**325 - 327 Deansgate – Manchester**

Non Material Amendment | 22 August 2022

10185-A-B5D8-RP-DAS-002

## 1.0 Introduction

### Typical Floor Plan 2

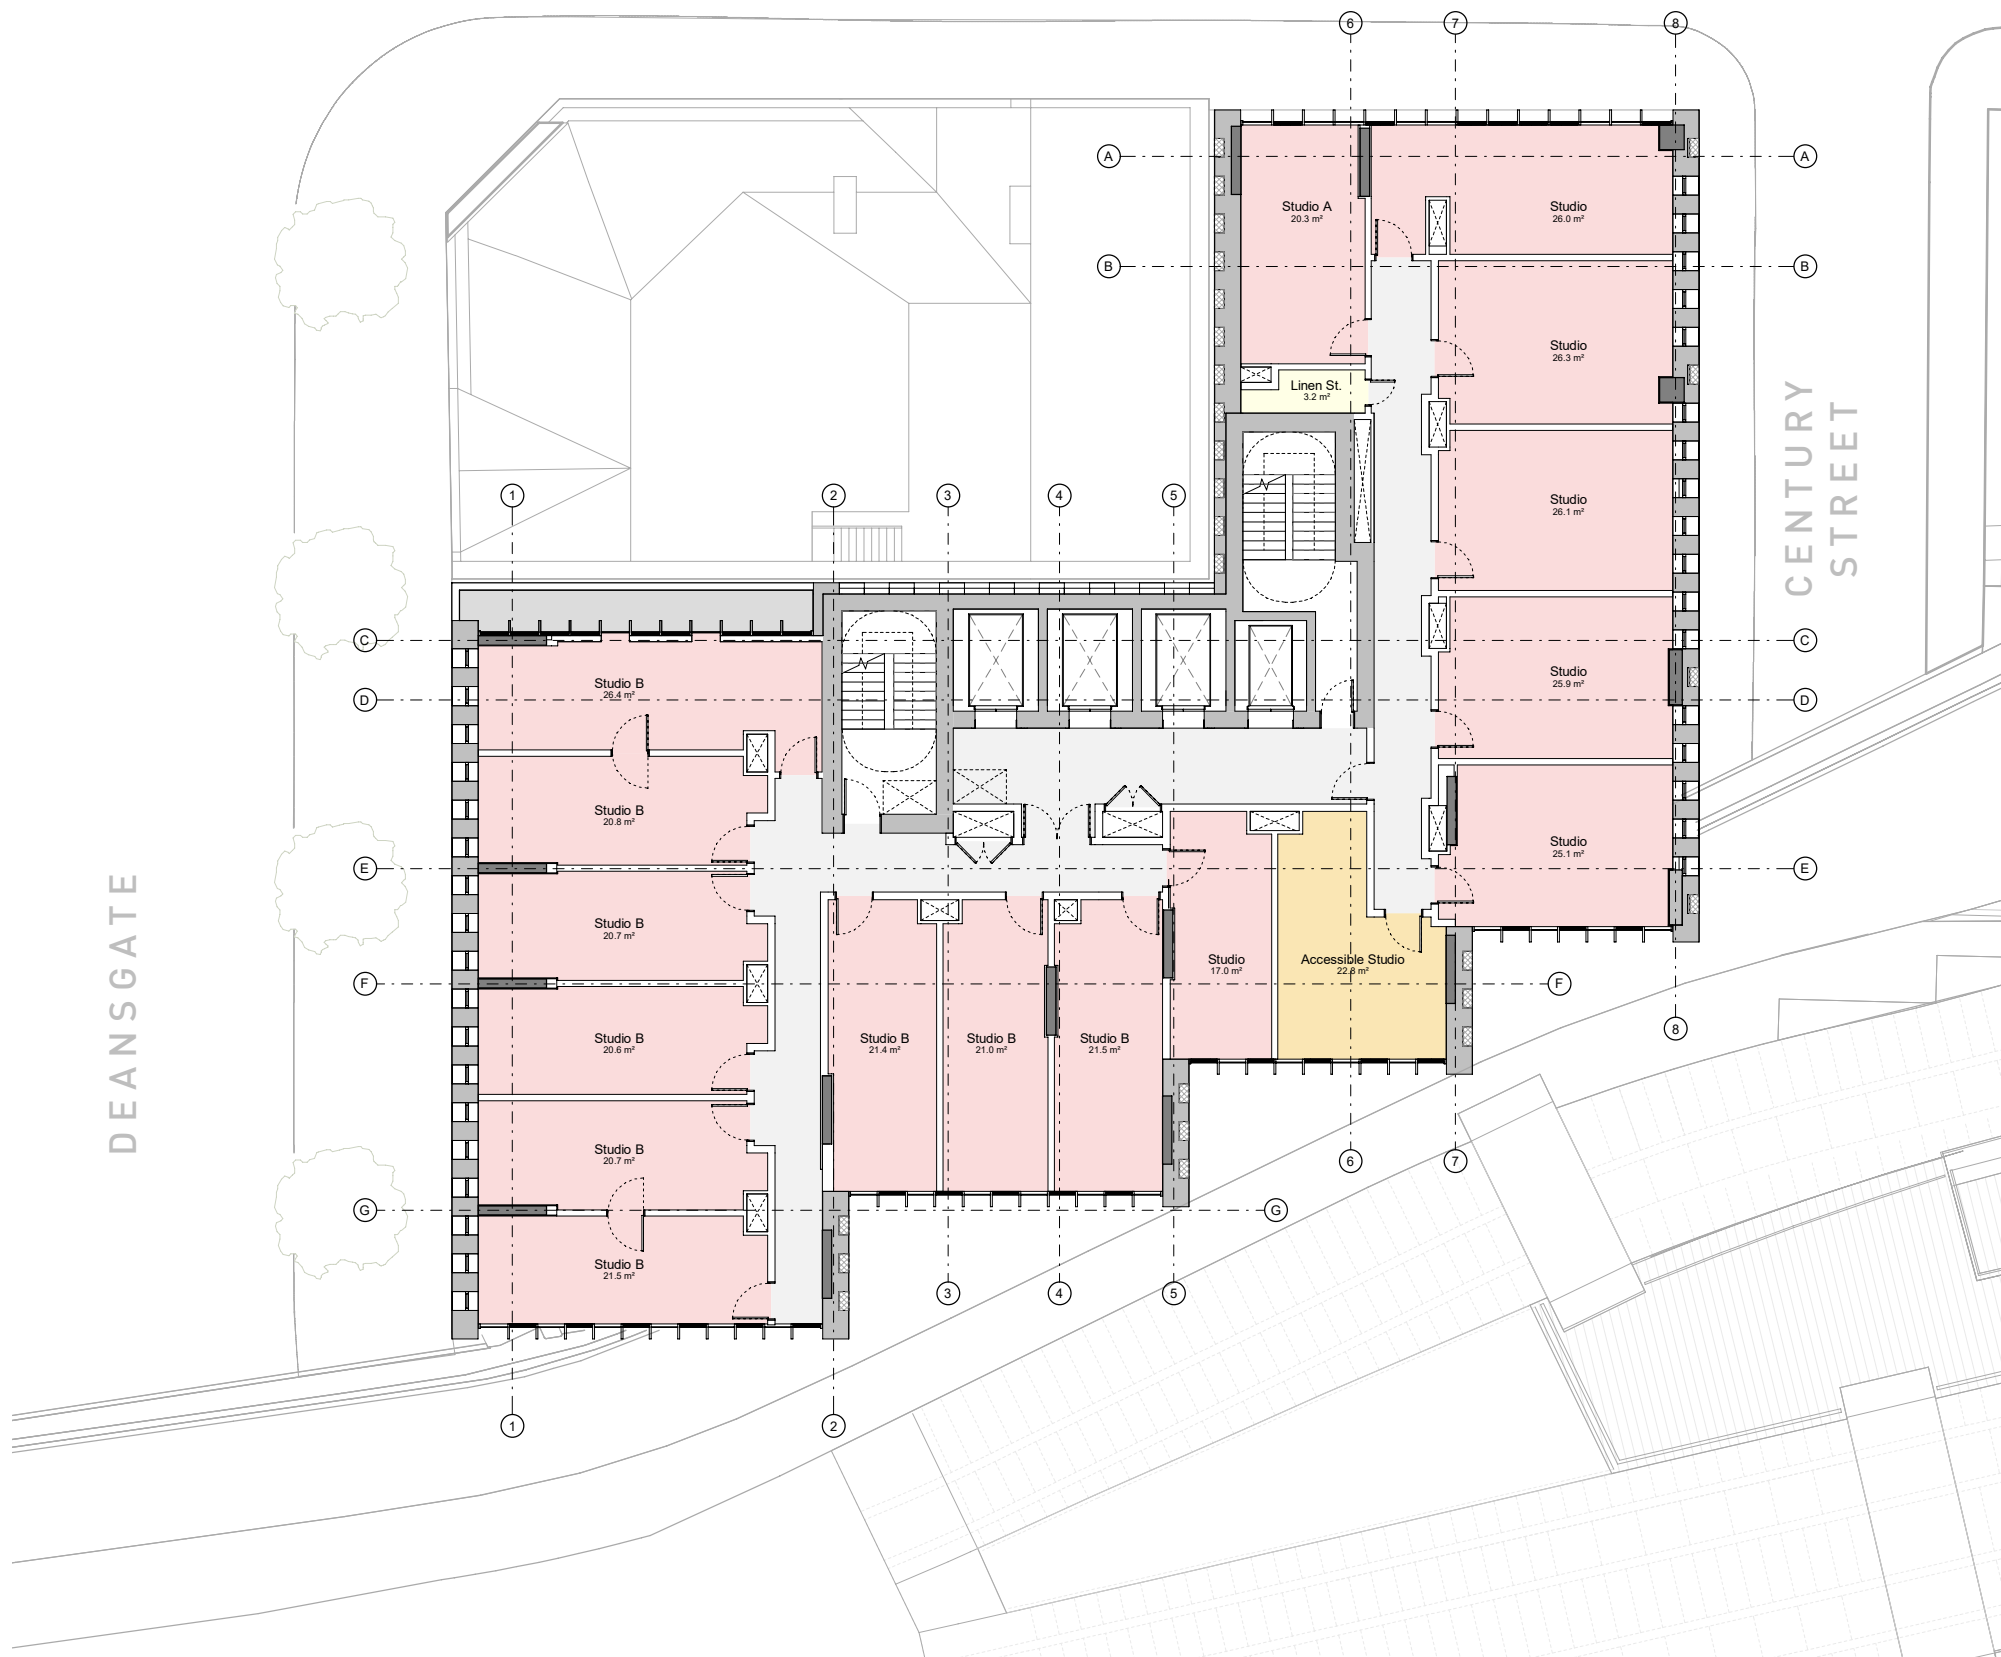
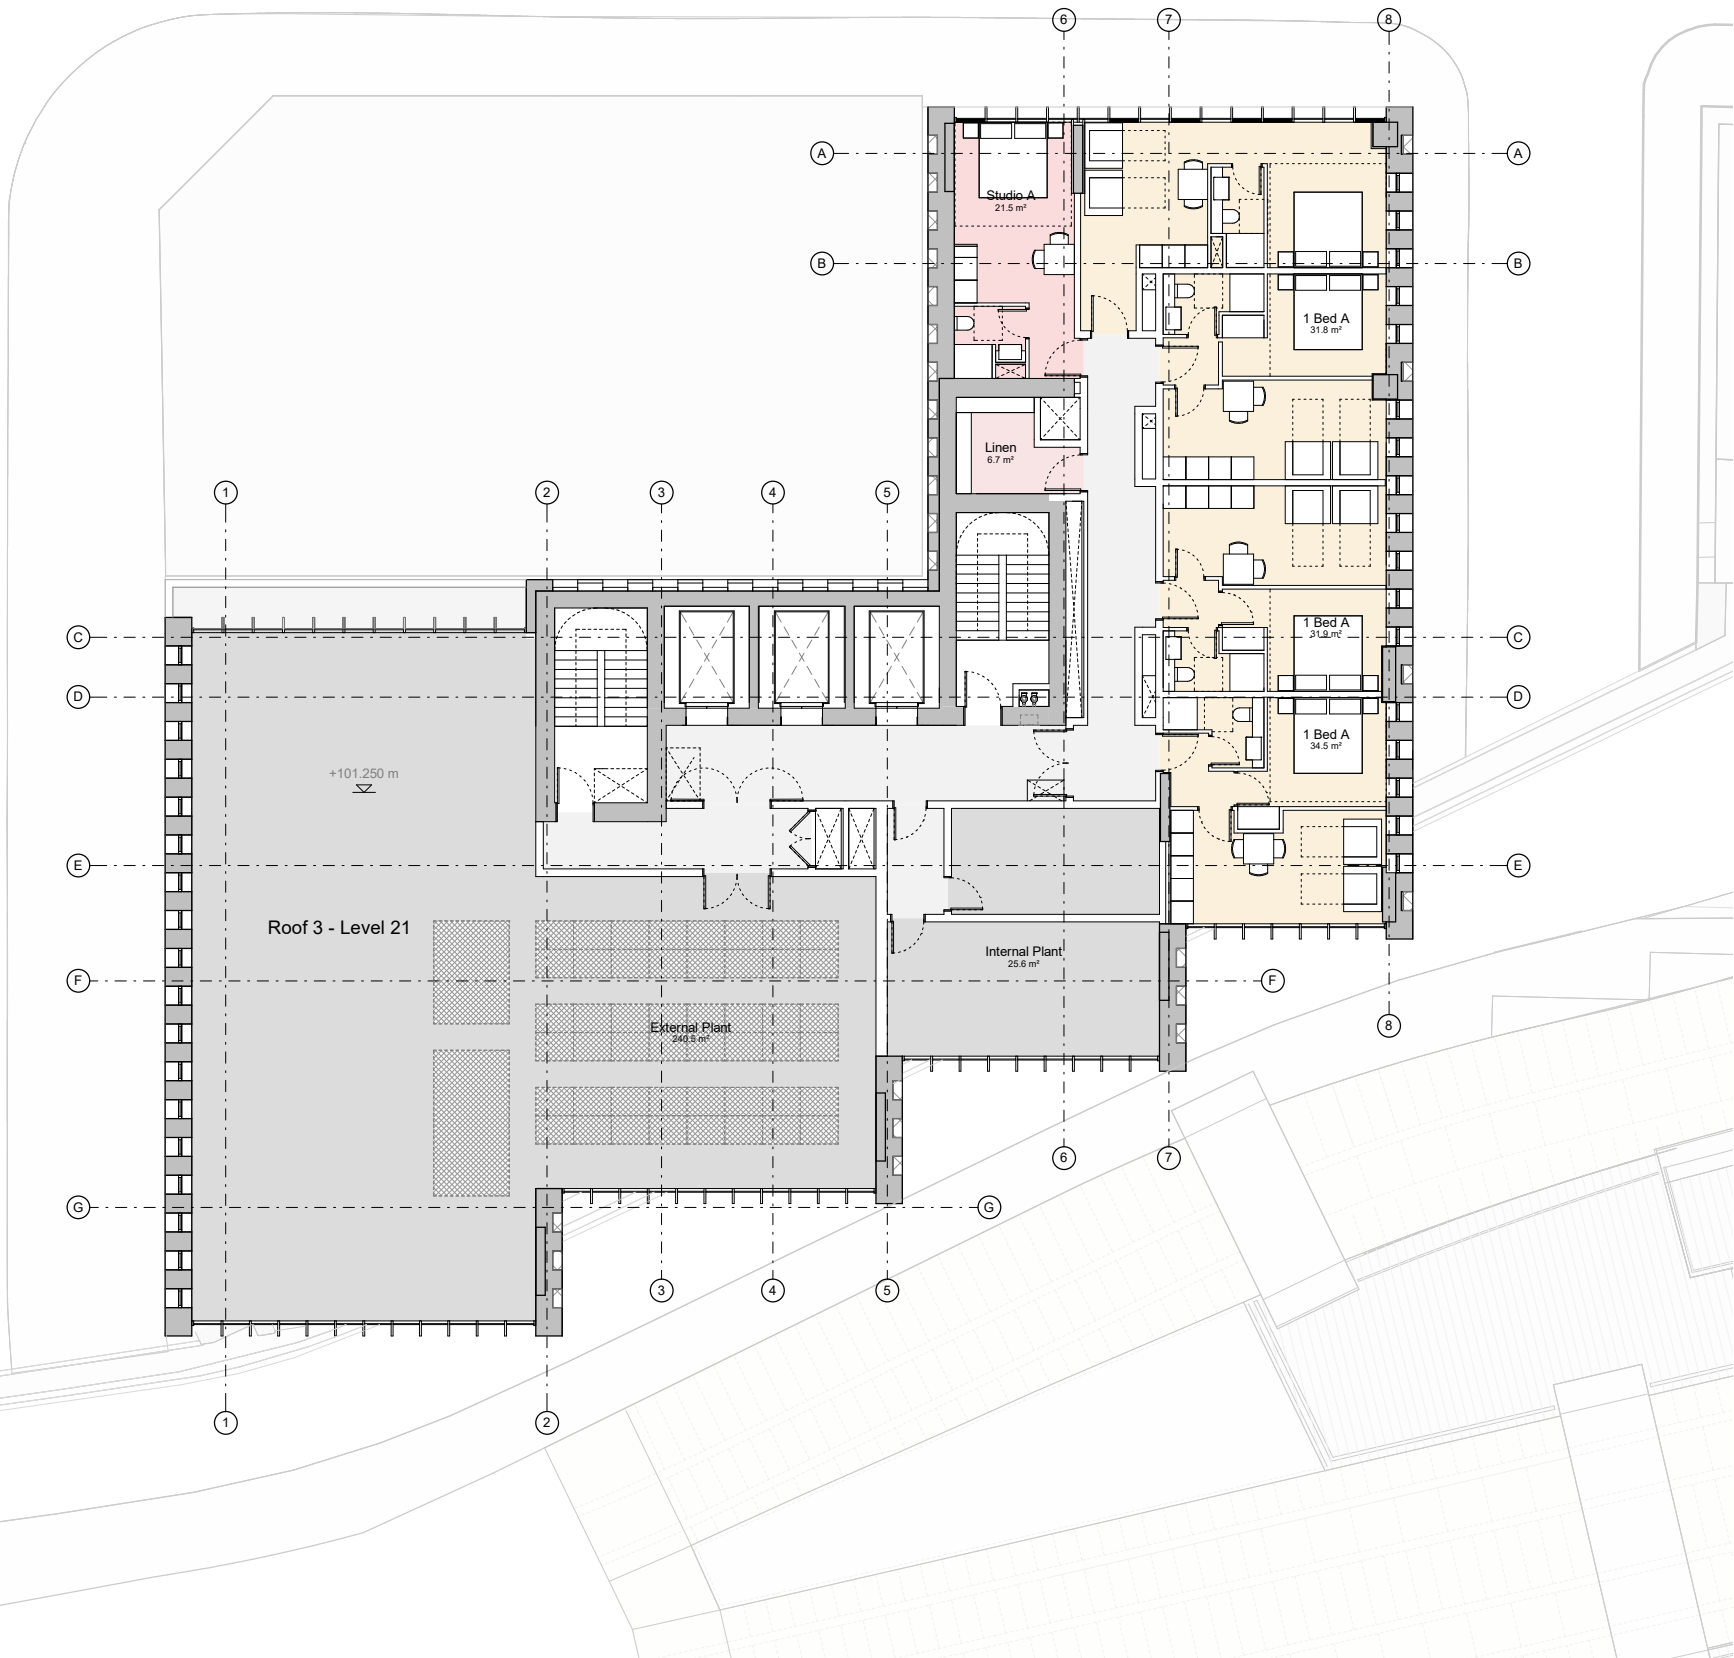
Amendments to typical level 2

- Lift/stair arrangements amended as described at ground floor.
- Hotel room layout on Century Street frontage amended to introduce studios in lieu of one bed apartments

### level 21 Plan

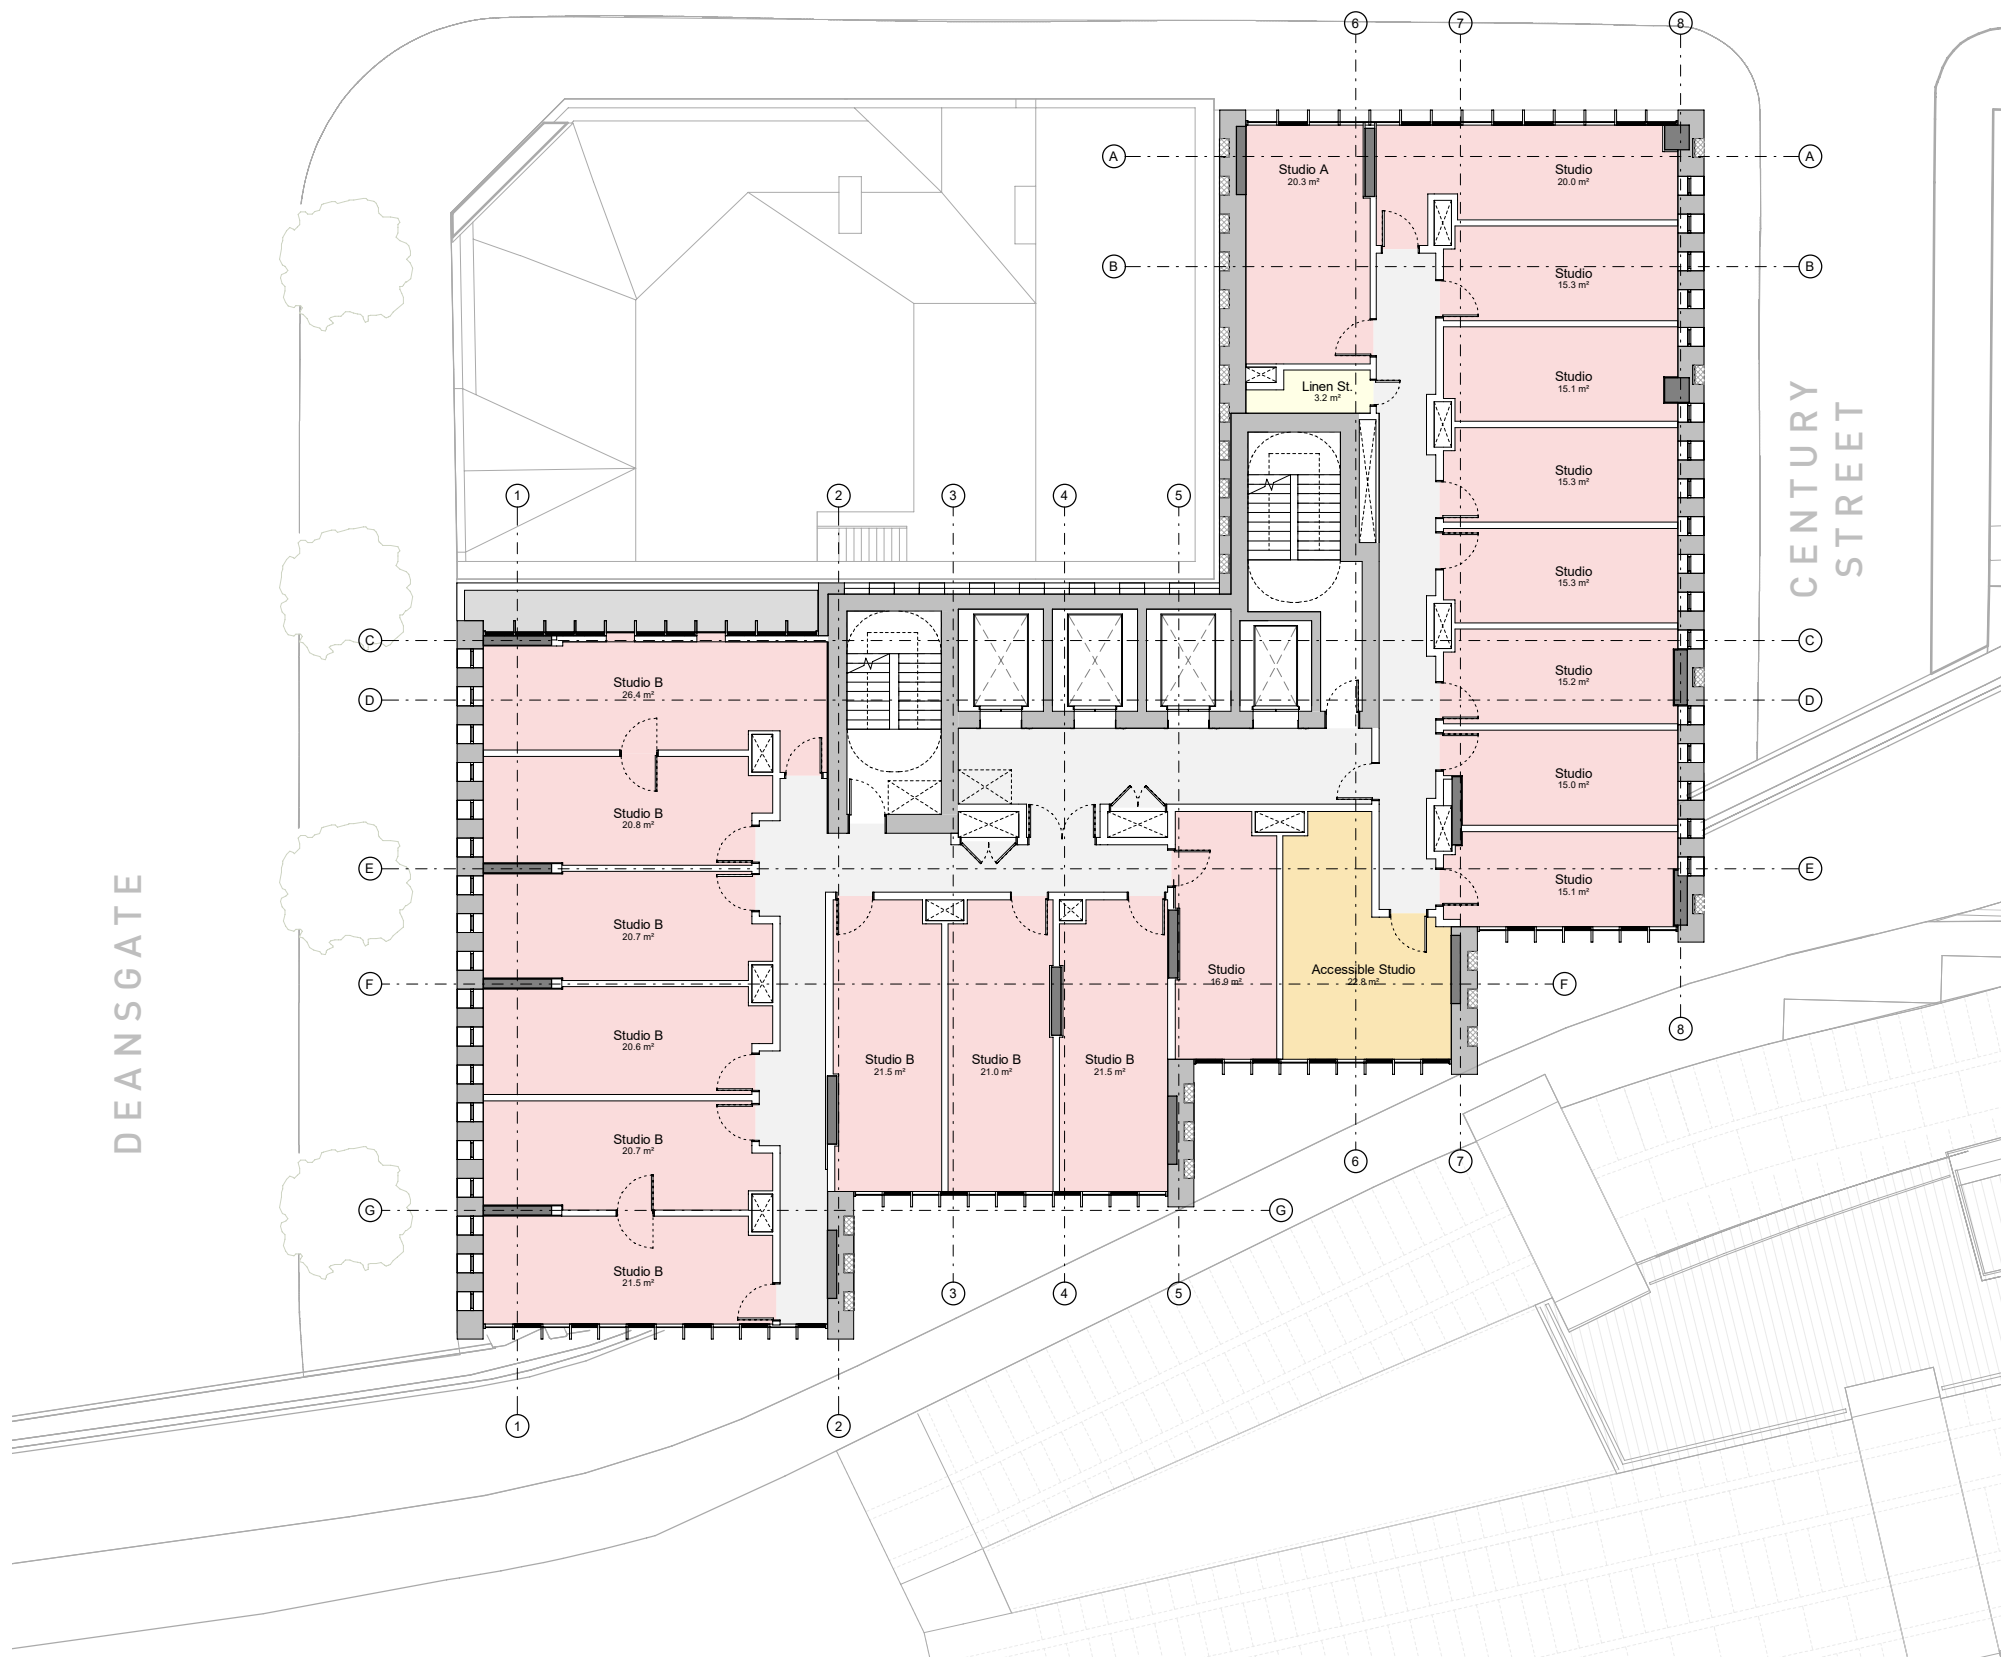
#### Amendments to Level 21

- Lift/stair arrangements amended as described at ground floor.
- Hotel rooms extended into space previously occupied by plant well.
